SERVICE BULLETIN

APPLICABILITY: 2012MY and Later Impreza Models with FB Engine **NUMBER:** 02-141-13
 2011MY and Later Forester, N/A and Turbo Models **DATE:** 05/28/13

SUBJECT: Design Change to Rubber Sealing Cap for Oil Pressure Switch

**Original
(old style) cap**

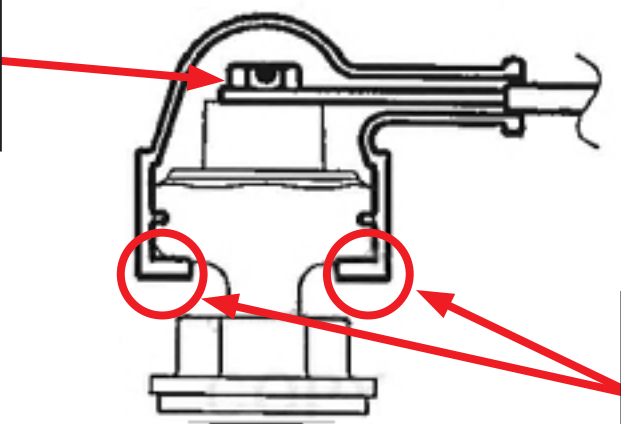
This Bulletin provides information regarding a design change to the rubber cap which covers the electrical connection at the oil pressure switch. The new cap provides better sealing and resistance to moisture intrusion which can compromise the electrical connection and in some cases, cause the oil pressure warning lamp to illuminate in error.

**4 seal breaks have
been added on the
new cap as shown.**

Be sure to follow the applicable procedure for tightening this electrical connection terminal as it varies by model.

The seal must be installed as shown with no roll-up of any of the edges.

Follow the procedure in the applicable Service Manual if replacing the oil pressure switch. Be sure to follow the proper torque procedure for both the switch **and** the electrical connection where applicable as it varies by model. The rubber material used to make the cap is soft and pliable enough so the wire and terminal eyelet can be pushed through the “tube” portion easily. Use a little bit of dielectric grease on the terminal eyelet as a lubricant if necessary. Confirm the new rubber cap is installed as shown in the illustration above with no roll-up of the bottom sealing edges.
